Addendum No. 02

TO: PLANS AND SPECIFICATIONS FOR STATE OF MISSOURI

Construct Six New Cabins
Echo Bluff State Park
Eminence, MO
Project No: X2208-01

1 ELECTRICAL SITE PLAN
SCALE: 1" = 30'-0"

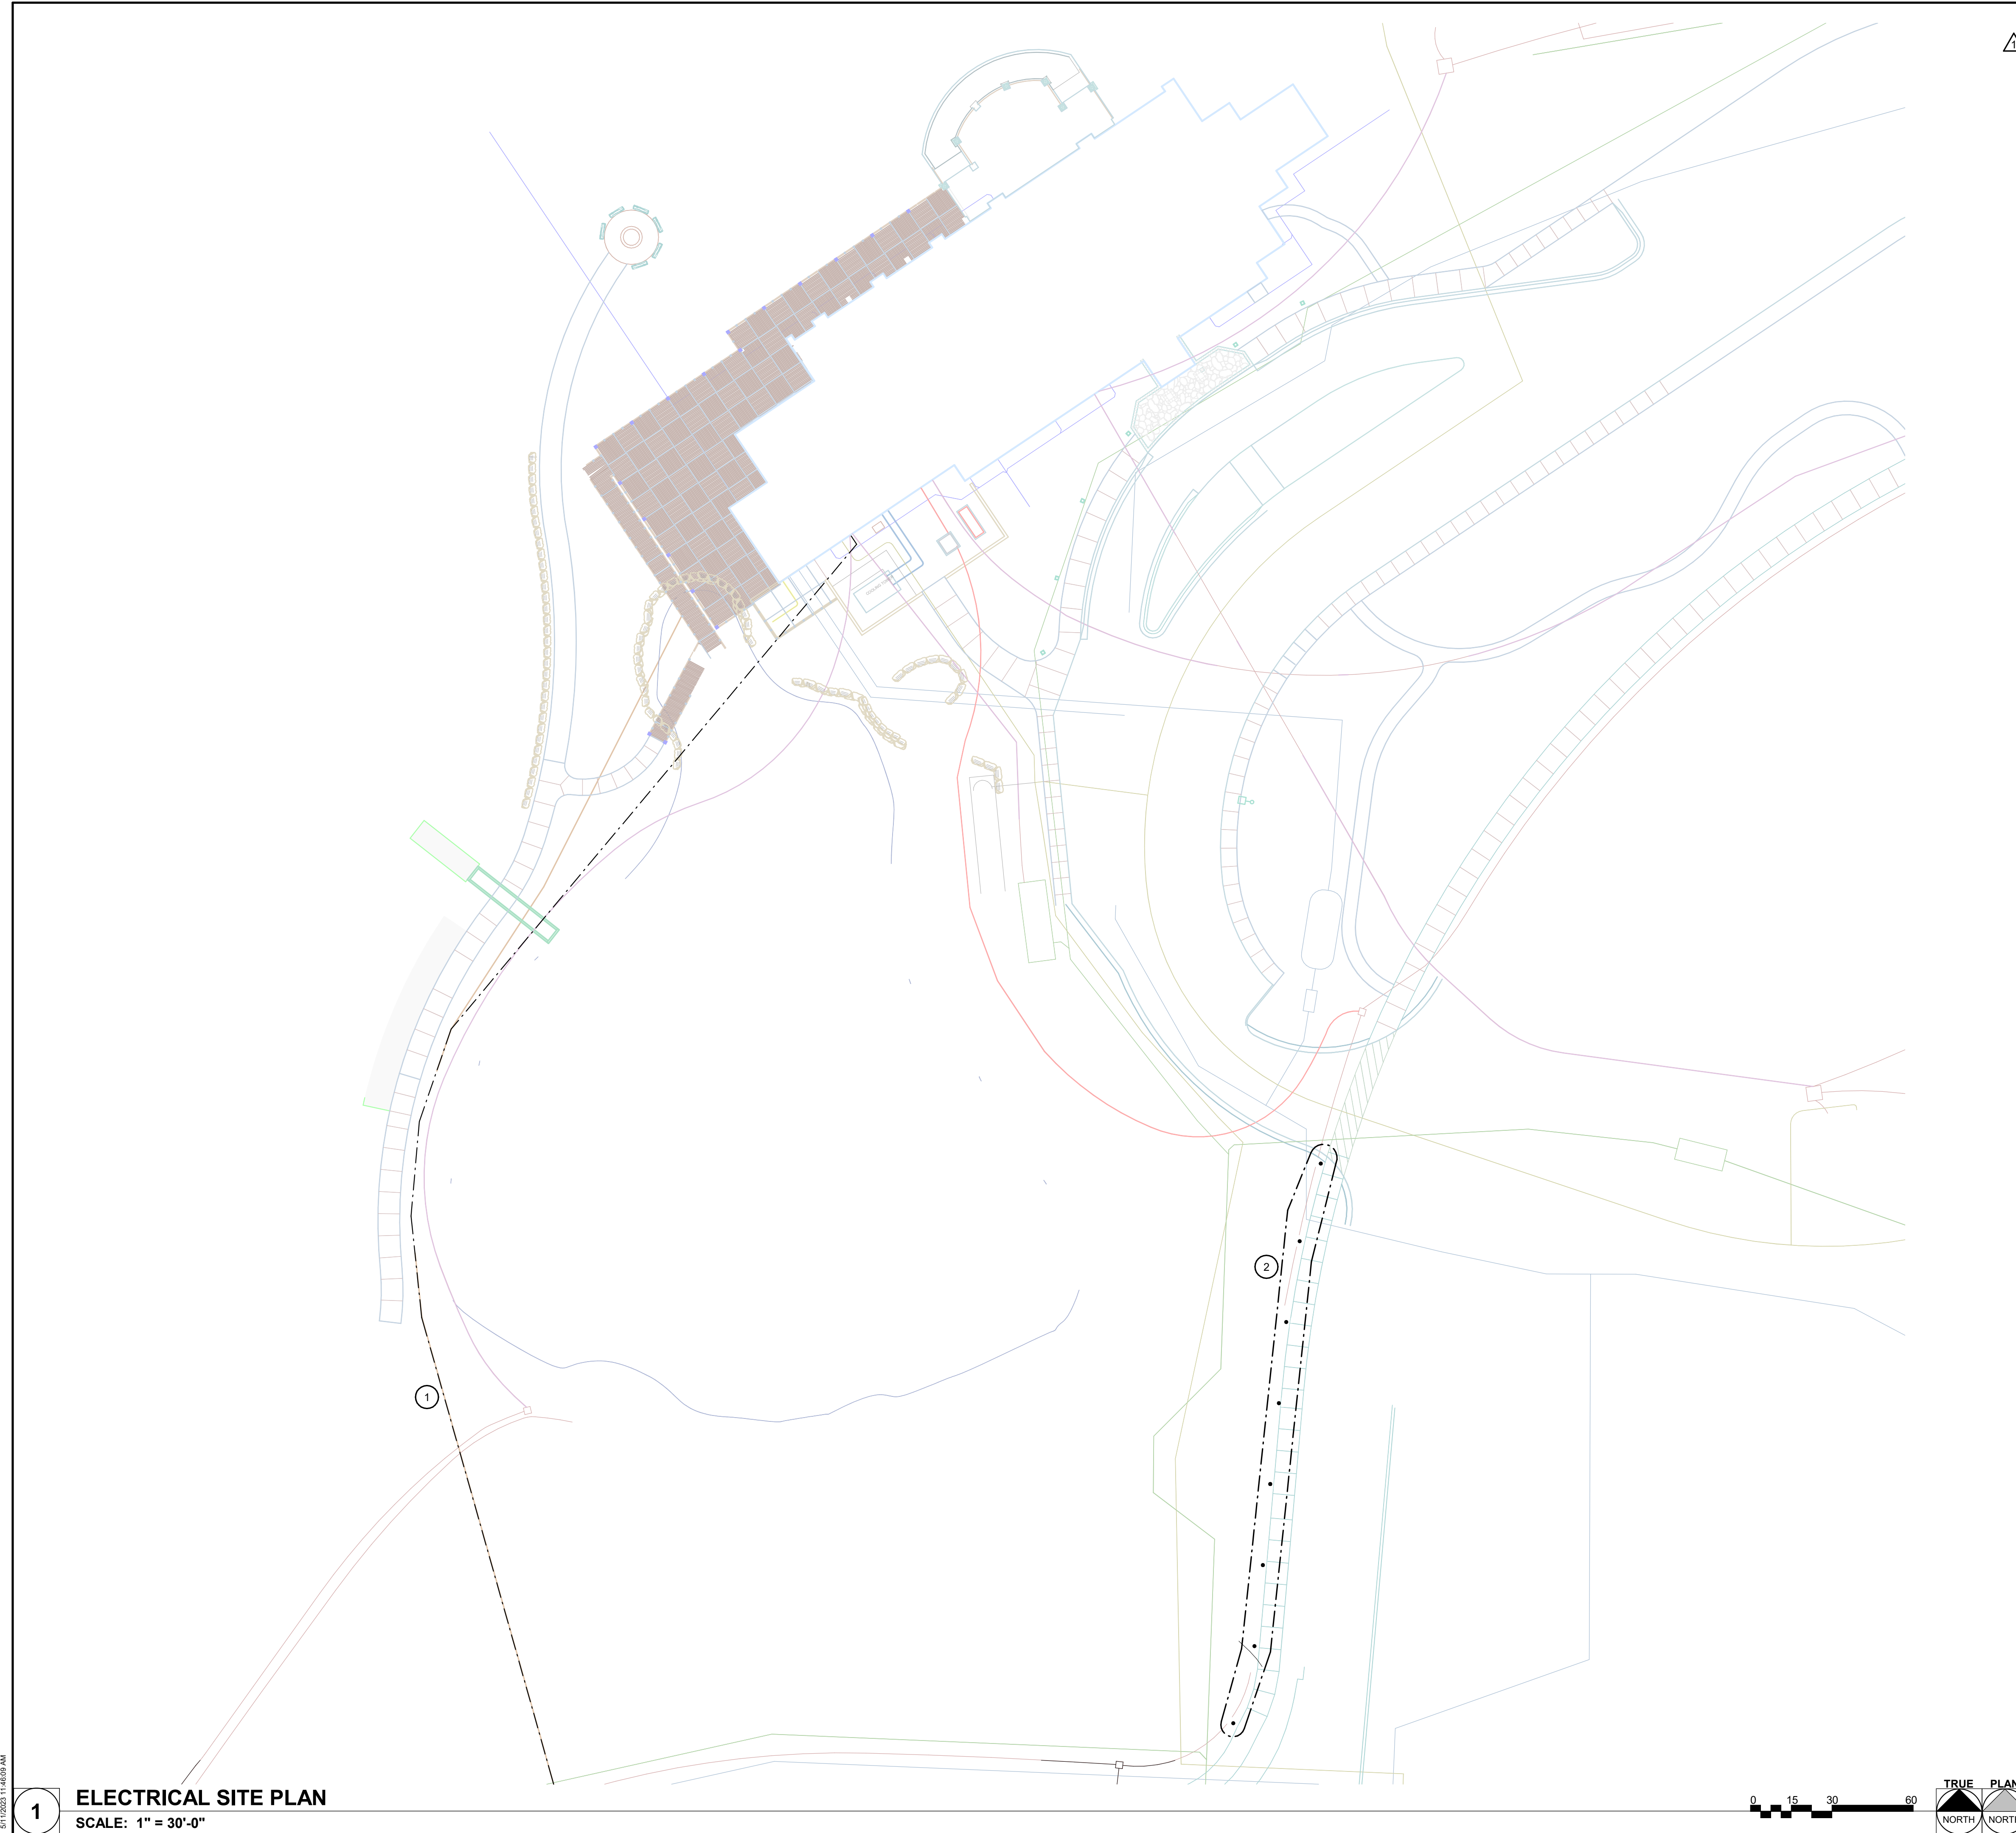
4. Sheet E-402 – See Attached revised sheet E-402

a. ADD general note A as follows:

b. ADD general note B as follows:

A. PROVIDE PULL BOXES FLUSH WITH EVERY 300' ALONG TELEPHONE FIBER CONDUIT. PROVIDE A PEDESTAL EVERY 900' ALONG TELEPHONE FIBER. THE PEDESTAL SHALL AS A PULL BOX. PROVIDE ADDITIONAL PEDESTALS AS NECESSARY TO ACCOMMODATE CABLE LENGTHS. SPLICING OF FIBER OPTIC CABLES WILL NOT BE ACCEPTABLE.

B. ALL PEDESTAL & DEMARCATION LOCATIONS MUST ACCOMODATE FIBER TERMINATIONS TO BE MOUNTED. LOCKED AND MAINTAINED BY STATE OF MISSOURI (SOM) STAFF.
